SUBJECT: Entergy Nuclear Operations Inc.
Indian Point Nuclear Generating Unit Nos. 2 & 3
Docket Nos. 50-247 and 50-286
Amendment 3 to License Renewal Application (LRA)

This letter contains Amendment 3 of the License Renewal Application (LRA), which consists of five attachments. Attachment 1 consists of an amendment to the LRA to address Regional Inspection items. Attachment 2 consists of an amendment to address Audit Time Limited Aging

ATTACHMENT 1 TO NL-08-057

Regional Inspection LRA Amendment

Figure 2.5-2
IP2 Offsite Power Scoping Diagram

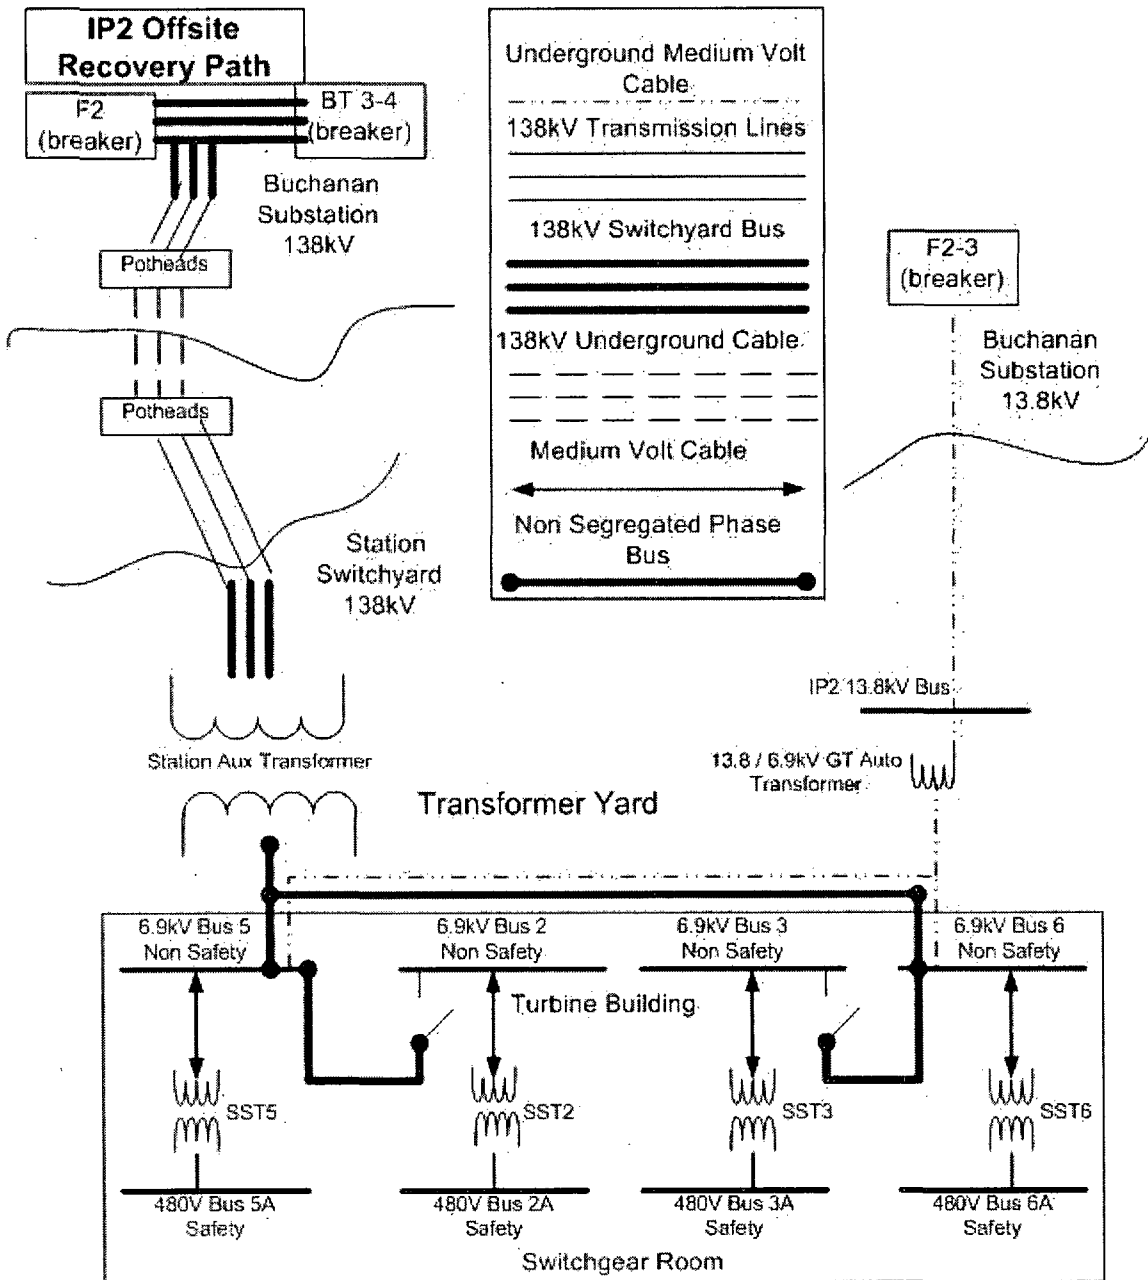
Based on discussion with the NRC Staff on 12/4/07 and industry discussion with the NRC Staff on 12/12/2007 and 1/30/2008, the response to this RAI provided in Entergy Letter NL-07-138, Dated 11/16/2007 is being revised. The only section that requires revision is LRA Figure 2.5-2 and associated discussion.

As shown in the revised LRA Figure 2.5-2, the 6.9 kV buses receive offsite power from either the 138 kV / 6.9 kV station auxiliary transformer or the 13.8 kV / 6.9 kV GT autotransformer. The station auxiliary transformer is connected to the 138 kV Buchanan substation, the primary offsite power source, via switchyard bus, overhead transmission conductors, and underground transmission conductors through ~~motor-operated disconnect F3A~~ switchyard breakers F2 and BT 3-4, which ~~is~~ are located at the Buchanan substation. The GT autotransformer is connected to the 13.8 kV Buchanan substation, the secondary offsite power source, via underground medium voltage cable through breaker F2-3, which is located at the Buchanan substation.
